Service Bulletin

| Subject: REAR CONSOLE LID IS LOOSE | Bulletin No: 09-045/14 |
| | Last Issued: 10/23/2014 |

2014 Mazda6 vehicles with VINs lower than JM1 GJ ***** 186473 (produced before May 14, 2014)

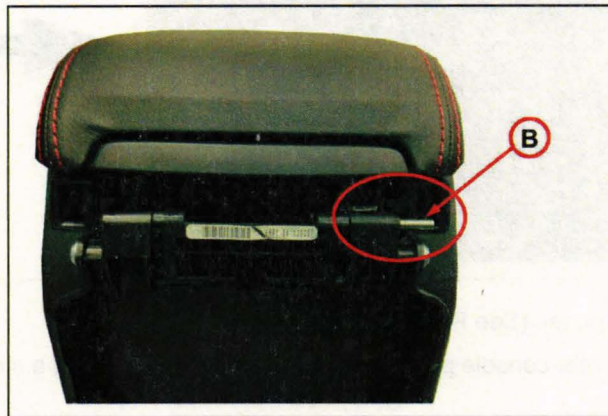
Some customers may complain about a loose rear console lid (A).

This may be caused by hinge pins coming partially off (B) or completely off.

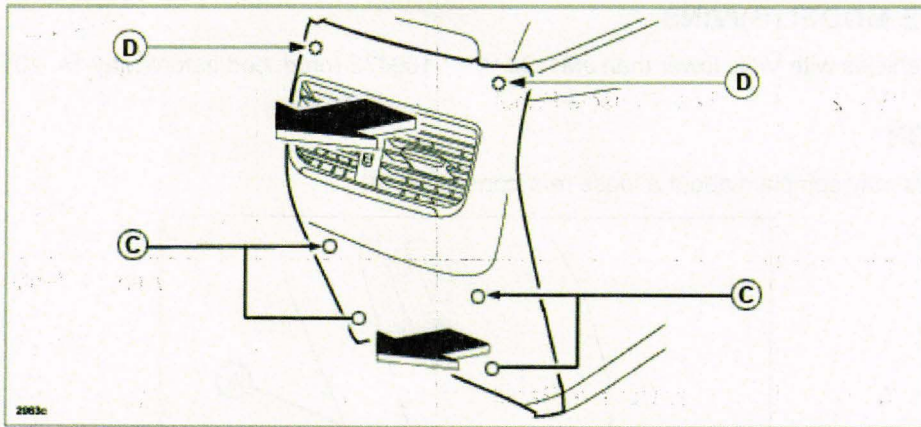
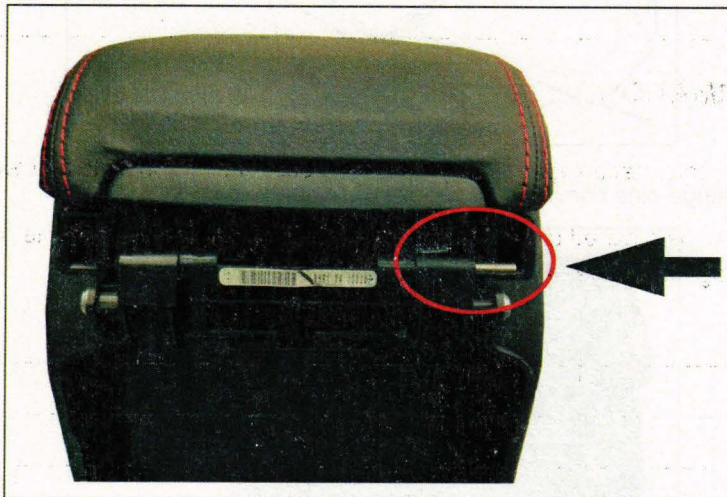
1. Verify customer concern.
2. Remove the rear console panel by pulling in the direction of the arrows shown below.

NOTE: Begin by pulling from the bottom to detach inner attachment clips (C), then continue pulling from the top to detach inner attachment clips (D).

3. Re-install the rear console lid pin(s) back to the original position.

4. Install a new rear console panel. (See PART(S) INFORMATION)

NOTE: The shape of the rear console panel has been changed, by adding a stopper rib to prevent the pin from coming off.
